## Modification Bulletin

Model: Model K3 Date			e: 1-Nov-02		No.: MH310001	
Modified Article: F	Parts Catalog Corrections		Prepared	by: M.	Mano	
From: Technical Services sec. Service Planning Dept.						
Reason for	□ Parts catalog correction	☐ Vend	lor ch	ange	☐ To n	neet standards
Modification:	☐ To facilitate assembly	☐ To improve reliabilit		e reliability	(	)
	☐ Part standardization	☐ Othe	r

Model: Model K3

### New Part: The shaded hole [A] is closed

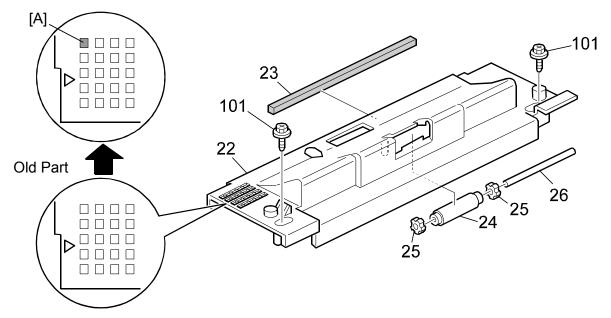
To facilitate assembly, the hole in the Exit Guide shown below has been closed (with no change in function).

Old part	New part	Description	Q'ty	Int	Page	Index	Note
number	number						
H3101196	H3101199	Exit Guide	1	X/O	15	22
